# Watts Bar Nuclear Plant Unit 2

Watts Bar Nuclear Plant (WBN) Unit 2
Pre-Submittal Meeting for Proposed Revision to WBN Unit 2 Capsule Withdrawal Schedule

| TABLE 4.0-1 Watts Bar Unit 2 Surveillance Capsule Removal Schedule <sup>(a)</sup> |                           |                |                      |  |  |  |  |  |

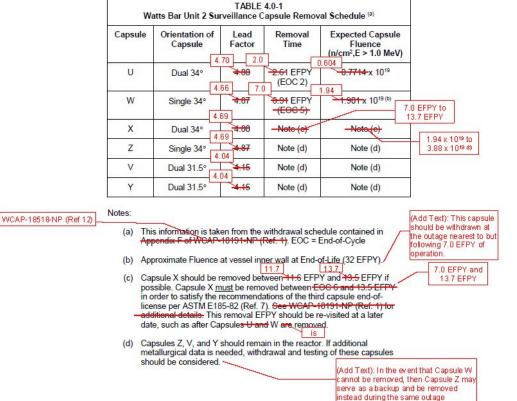
- Proposed change revises the withdraw schedule for reactor vessel surveillance capsule W
  along with the latest data regarding lead factors, effective full power years (EFPY), and
  expected neutron fluence, as well as the deletion of "EOC 5" from the Capsule W schedule
  line to allow planning of capsule withdrawal based on parameters that are directly applicable
  to ASTM E-185-82.

- The lead factors for all six capsules have been revised.
- The removal EFPY and expected neutron fluence for Capsule U has been updated to reflect the actual conditions achieved when the capsule was removed during U2R2 in spring 2019.
- The projected EFPY and expected neutron fluence for capsules W and X have been revised. These plant parameters are key indicators when ensuring compliance with ASTM E185-82 scheduling criteria.
- EOC 5 has been deleted from the Capsule W schedule line.

- Note (a) is being revised to replace WCAP-18191-NP with WCAP-18518-NP.
- Note (b) is being revised to indicate that Capsule W should be withdrawn at the outage nearest to but following 7.0 EFPY of operation.
- Note (c) is being revised to reflect the projected EFPY for Capsule X and to delete the references to WCAP-18191-NP and Capsule U because it has been removed.
- Note (d) is being revised to reflect that Capsule Z has been identified as a backup to Capsule W in the event that Capsule W cannot be removed during an outage. This change is acceptable because the two capsules are radiologically equivalent.

- As previously noted, the basis for these updates is WCAP-18518-NP, Revision 0, which has been submitted to the NRC.
- Table 1 to ASTM E-185-82 lists the recommended number of surveillance capsules and their withdrawal schedule based on the anticipated shift in the reference nil-ductility transition temperature (ΔRT<sub>NDT</sub>) at the end of life (EOL). For WBN Unit 2, the ΔRT<sub>NDT</sub> at EOL (i.e., 32 EFPY) for all vessel forgings and welds will be less than 100°F. Therefore, only three surveillance capsules are required to be withdrawn.

- In accordance with Table 1 to ASTM E185-82, the second capsule should be removed
  when the first of the following criteria is satisfied as shown in Table 1 on next slide. Based
  on the information in Table 1, the limiting criterion for WBN Unit 2 is when the fluence will
  correspond to the approximate EOL fluence at the reactor vessel inner wall location.
  Table 2 on the next slide shows the fluence projection for the WBN Unit 2 surveillance
  capsules.

- The basis for deleting EOC 5 from the Capsule W schedule line is that this information was originally included as a planning tool to assist the utility with withdrawing the capsule at the expected time. However, recent adjustments in lead factors, estimated EFPY to attain target fluence, and a reconciliation of actual accrued EFPY to date has shown that U2R5 is too early to satisfy the requirements of ASTM E-185-82. Therefore, the (EOC 5) information has been deleted from the schedule to allow planning of capsule withdrawal based on parameters that are directly applicable to ASTM E-185-82.
